Model: OR-C2		Date: 20-Sep-13	No.: RD184001
Subject: Data Overwrite Security Unit Type I		Prepared by: T. Nihei	
From: 2nd Tech Service Sect., MFP/P Tech Service Dept.			
Classification:	<input type="checkbox"/> Troubleshooting	<input type="checkbox"/> Part information	<input type="checkbox"/> Action required
	<input type="checkbox"/> Mechanical	<input type="checkbox"/> Electrical	<input checked="" type="checkbox"/> Service manual revision
	<input type="checkbox"/> Paper path	<input type="checkbox"/> Transmit/receive	<input type="checkbox"/> Retrofit information
	<input type="checkbox"/> Product Safety	<input type="checkbox"/> Other ()	<input type="checkbox"/> Tier 2

Service Manual Revision

Please revise the following in the Service Manual.

Data Overwrite Security Unit Type I (D362)

34. Controller Section (D182/D183/D184)

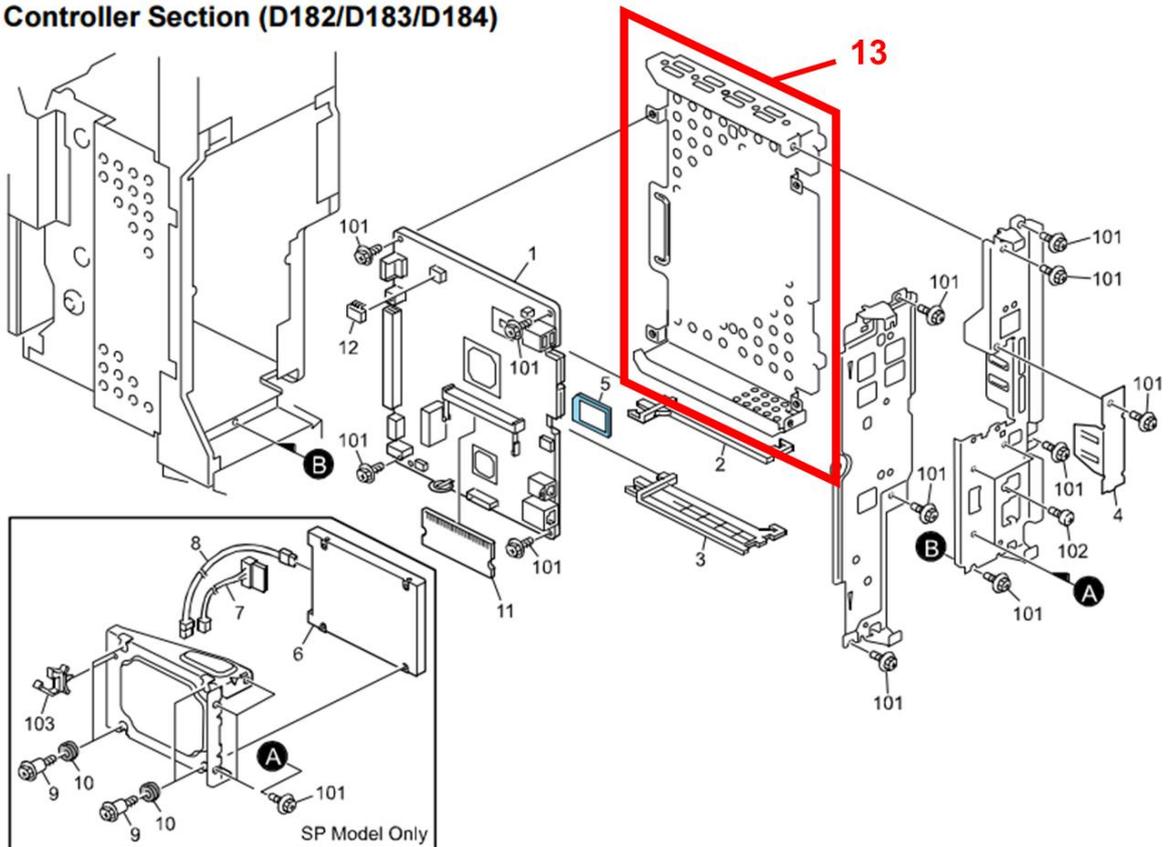
Old part number	New part number	Description	Q'ty	Int	Page	Index	Note
-	D1825859	BRACKET:CTL:PEEN	1	-	69	13	-

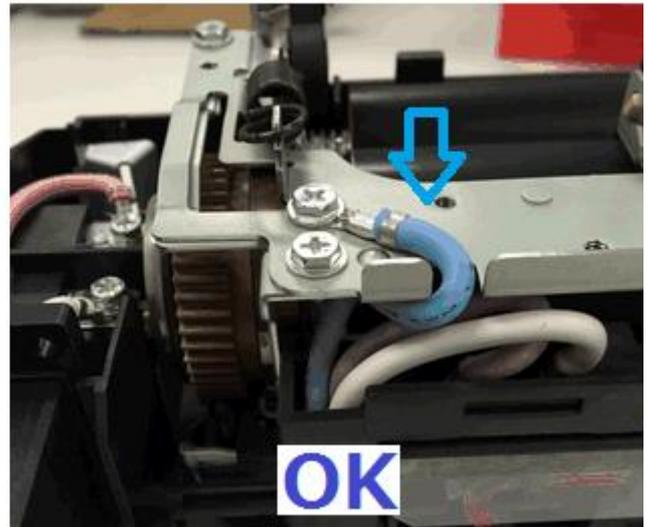
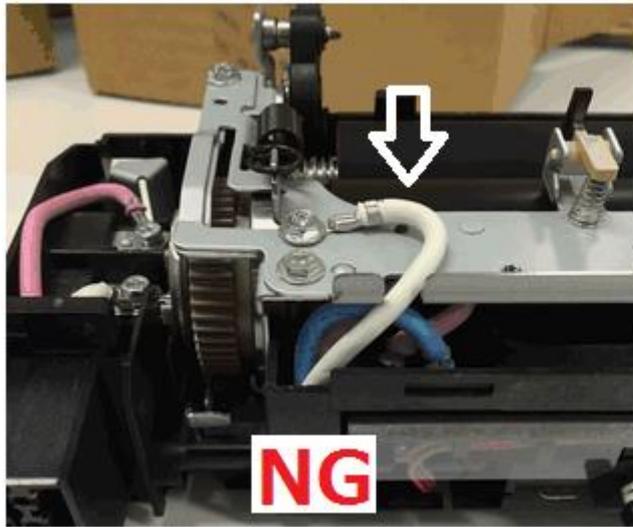
The wiring was done incorrectly at the factory. Specifically, the blue wire (FG) should be screwed to the metal frame, but instead, the white wire (L) is used for grounding. In addition, the testing device used to detect such errors was not working properly.
